To: **Planning Services
Lake District National Park Authority
Murley Moss
Oxenholme Road
KENDAL
LA9 7RL**

**OBJECTION TO PLANNING APPLICATION 7/2018/3087
INSERTION OF MULTIPLATE ARCH UNDER BRIDGE 94 AT GILLSROW**

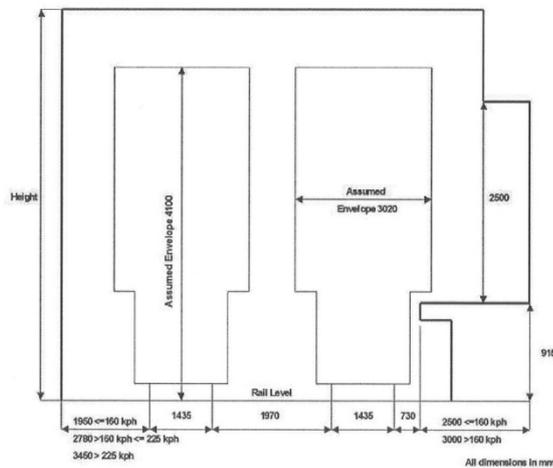
The work actually needed is to replace the bridge deck which has become weak. For a structure of such age, designed for lighter traffic replacement now should not be unexpected.

The Applicant has not demonstrated that the proposed method is the most cost effective or has more long term benefits than simply replacing the deck with a modern fabricated items designed to carry modern road vehicles.

CKP Railways plc believes that the method proposed would require more work on site, and be more disruptive to neighbours but not guarantee the long term future of the bridge.

CLEARANCES REQUIRED BY RAILWAY GROUP STANDARD GE GN 8573

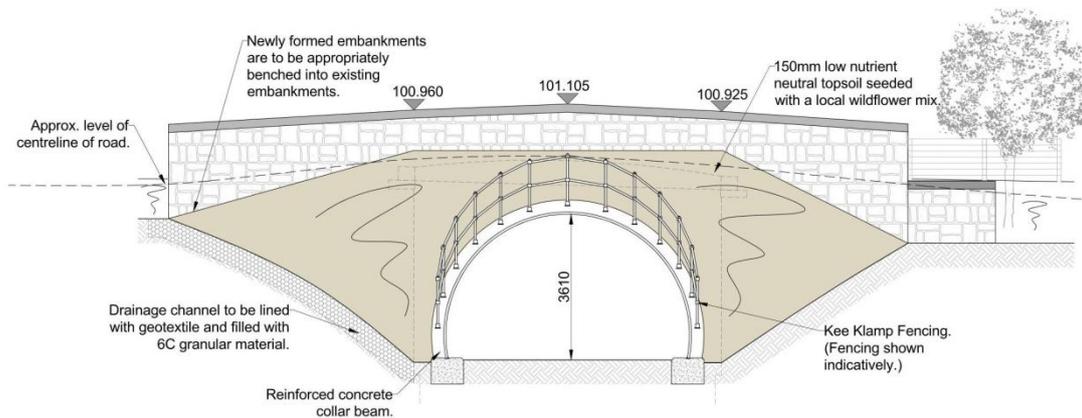
The diagrams below indicate the clearance required by the current Railway Group Standards applicable to modern main line railways to carry passenger and freight trains, against the clearances which the Applicants' work would provide.

Clearly it will be impossible to operate modern trains through the bridge as modified by the Applicants' proposed work.

CLEARANCES WHICH WOULD BE LEFT BY THE APPLICANTS' PROPOSAL

Modern trains require a clear height of more than 5 metres below a bridge deck with a flat top profile (rectangular space) to allow for train + track + ballast above formation level.

Clear width required for double track through structures minimum 7.2 metres (vertical wall).
Clear width required for double track through structures minimum 3.8 metres (vertical wall).
